Subject: Questions for Consumers Power Company Concerning the Deformation  
of Buried Piping Due to Differential Soil Settlement at Midland  
Plant Units 1 & 2

QUESTIONS FOR CONSUMERS POWER COMPANY CONCERNING  
THE DEFORMATIONS OF BURIED PIPING DUE TO  
DIFFERENTIAL SOIL SETTLEMENT AT MIDLAND PLANT UNITS 1 AND 2

Midland Plant Units 1&2  
Bending Stresses in Underground  
Piping Due to Differential  
Soil Settlement

SUBJECT: Interagency Agreement No. NRC-03-79-167, Task No. 1 - Midland Plant  
Units 1 and 2, Subtask No. 1 - Letter Report

FIG 19.1 Ref 1

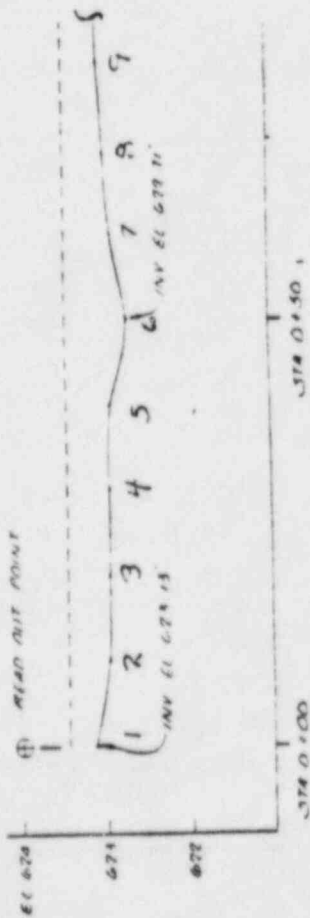
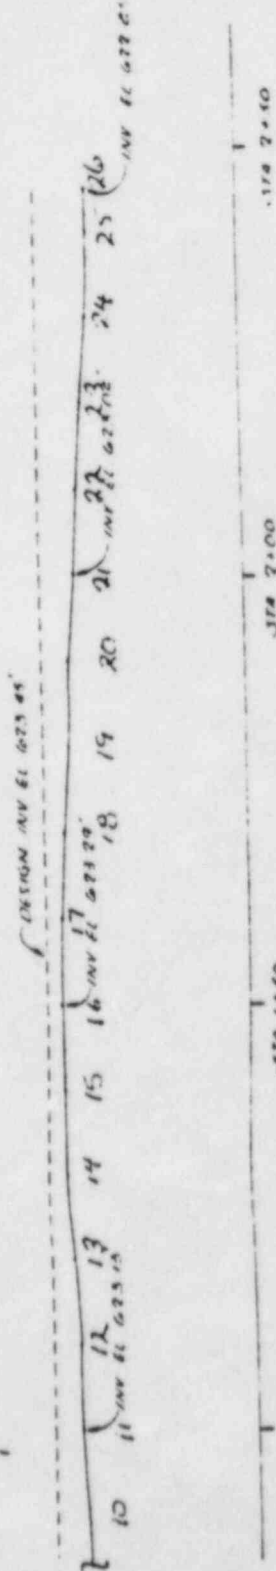
THE PROFILES OF SEVERAL OF THE LINES OF FIGURES 17.2 AND 19.1 OF REF. 1 WERE ANALYSED BY AN ETEC IN-HOUSE COMPUTER PROGRAM IN AN ATTEMPT TO VERIFY THE MAXIMUM STRESSES FOR THESE LINES PER REF. 1. THE MAXIMUM STRESSES OBTAINED FROM THIS ANALYSIS WERE CONSIDERABLY HIGHER THAN THOSE OF REF. 1. HAND CALCULATIONS WERE ALSO MADE AS AN ADDITIONAL CHECK, WITH THE RESULTS BEING SIMILAR TO THOSE OF THE COMPUTER ANALYSIS.

<u>LINE NO.</u>	<u>FIG</u>	<u>CASE</u>	<u>NODE</u>	<u>STRESS</u>
26"-OHBC-54	19.1	1	6	212200 PSI
"	19.1	2	6	216200 PSI
26"-OHBC-55	17.2	1	25	179200 PSI
"	17.2	2	2	46000 PSI
8'-1HBC-81	19.1	1	20	84700 PSI
"	19.1	2	20	85200 PSI
20" 1HCO-169	17.2	1	54	191800 PSI
"	17.2	2	54	192700 PSI

SIMPLE HAND CALCULATIONS WERE MADE TO VERIFY THE COMPUTER ANALYSIS FOR THE SECTION OF LINE R6" 43C-ST IN THE AREA OF THE DIP BETWEEN NODES 5 AND 7

5) THE METHOD GIVEN IN RESPONSE TO QUESTION 17 OF REF 1 IS AT BEST A ROUGH APPROXIMATION, BUT EVEN THIS METHOD GIVES VERY HIGH BENDING STRESSES FOR THE AREA BETWEEN NODES 5 & 7

IN ALL CASES THE STRESSES WERE WELL ABOVE THE YIELD STRENGTH OF THE MATERIAL AND ALSO THE CODE ALLOWABLES.

Profile 26" - OHBC-54 on Fig. 19-1 shows a sudden drop of approx. 0.2 feet within a distance of only 20 feet. Using the procedure on p. 17-2,

$$\sigma_b = 30000 \left( \frac{26}{2} \right) \left[ \frac{8(0.2)(12)}{(20 \times 12)^2} \right] = 130.0 \text{ KSI}$$

Furthermore, the Eq. 10(a) of Article NC-3652.3, Sec. III, Division 1, of the ASME code requires that some Stress Intensification Factor "1" be assigned to all computed settlement stresses. Yet, Table 17-2 lists only 52.5 KSI stress for this pipe. This matter requires further review. Please respond to apparent discrepancy and also specify the location of each computed settlement stress at the pipeline stationing shown on the profiles. More than one critical stress location is possible along the same pipeline.
